UNITED STATES
DEPARTMENT OF THE INTERIOR
BUREAU OF LAND MANAGEMENT

SUNDRY NOTICES AND REPORTS ON WELLS
Do not use this form for proposals to drill or to re-enter an abandoned well. Use Form 3160-3 (APD) for such proposals.

Lease & Well # :	Farrell Federal # 21
API # :	30-041-20689
County:	Roosevelt County

Farrell Federal 21
30-041-20689
Ridgeway Arizona Oil Corp
September 5, 2019
Conditions of Approval

Proposed Plug & Abandonment Procedure

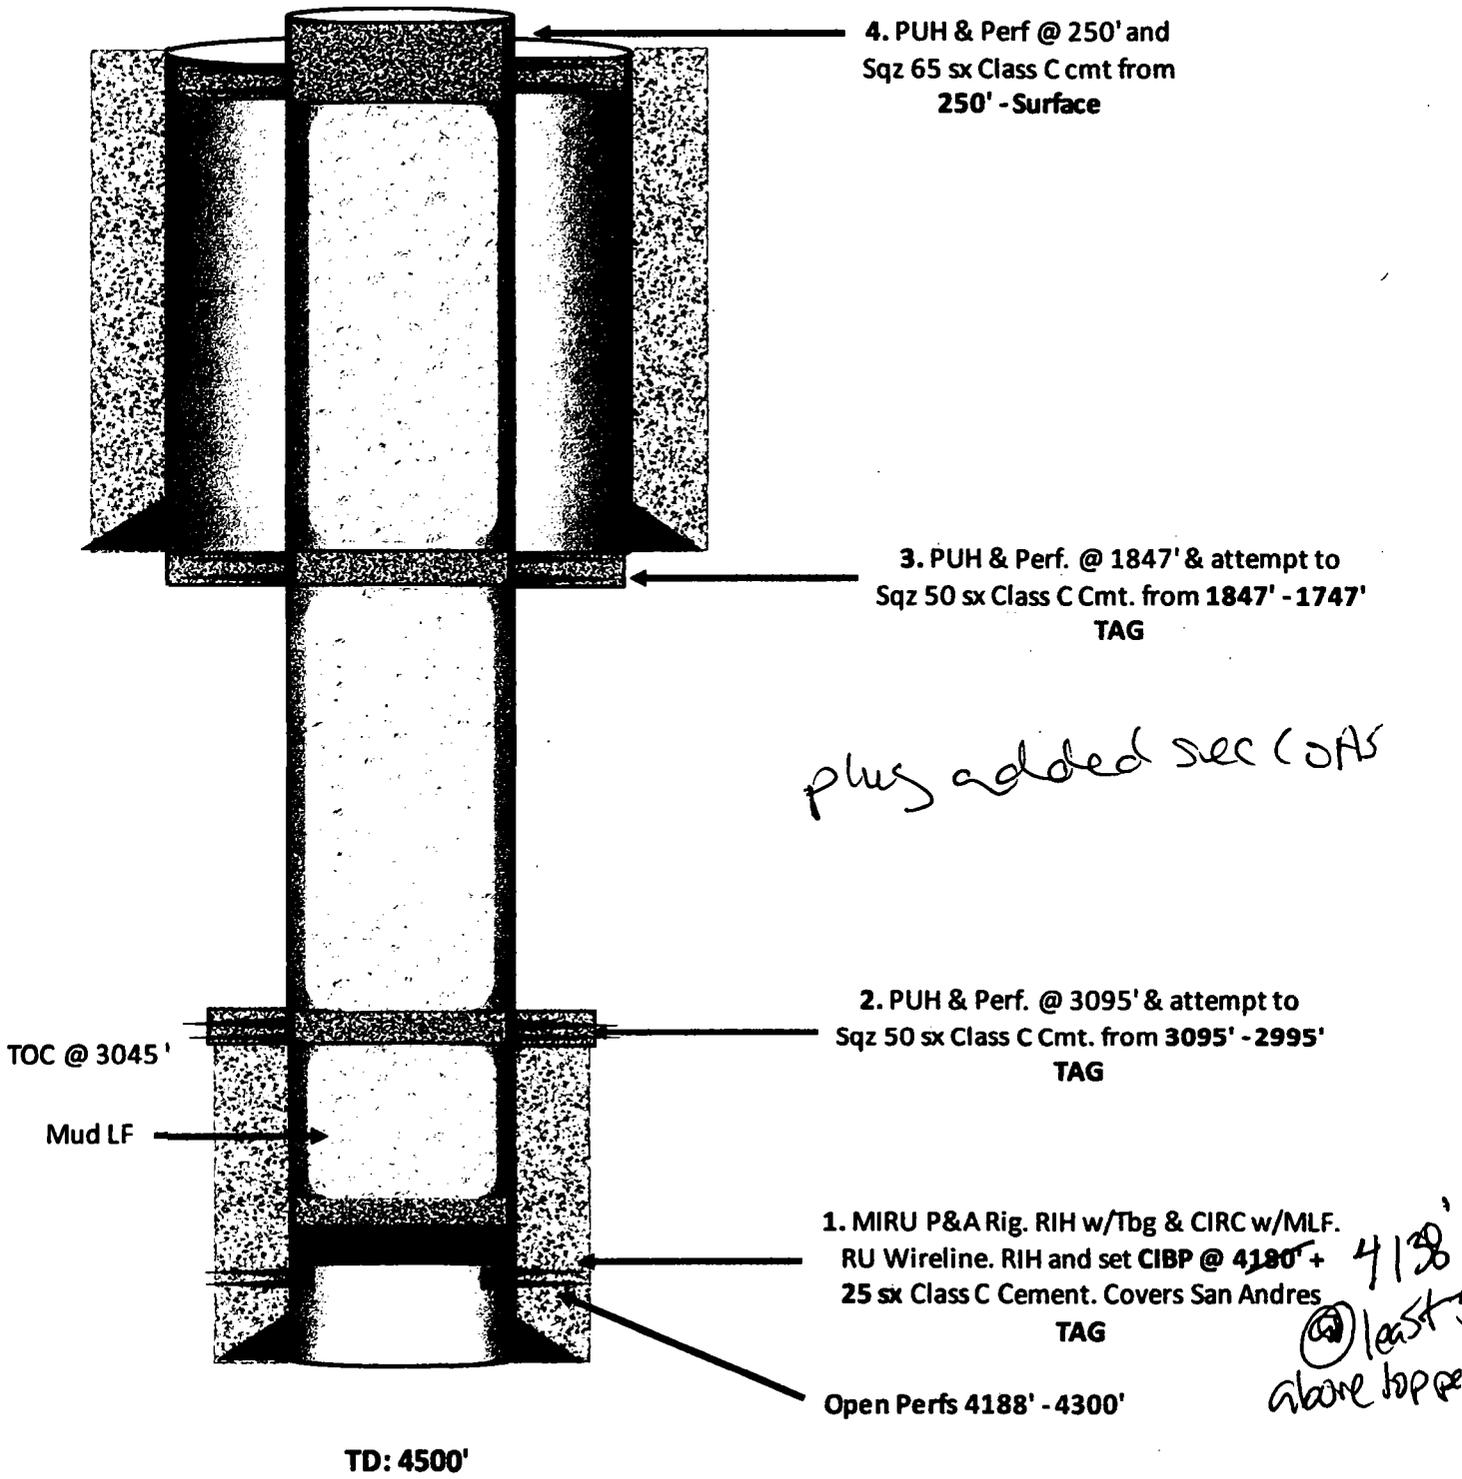
1. Operator shall place CIBP at 4,138' (50'-100' above top most perf) and place 25 sx of Class C cement on top as proposed. WOC and TAG.
2. Operator shall perf and squeeze at 3,095' as proposed. Operator shall place a balanced Class C cement plug from 3,095'-2,995' as proposed. WOC and TAG.
3. Operator shall perf and squeeze at 2,335'. Operator shall place a balanced Class C cement plug from 2,335'-2,210' to seal the Yates Formation and the bottom of the Salt. WOC and TAG.
4. Operator shall perf and squeeze 50 sx of class C cement as proposed at 2,050. Operator shall place a balanced Class C cement plug from 2,050'-1,747' to seal the top of the Salt and the 8-5/8" shoe. WOC and TAG as proposed.
5. Operator shall perf and squeeze at 250' as proposed. Operator shall place a balanced Class C cement plug from 250' to surface.
6. See Attached for general plugging stipulations.
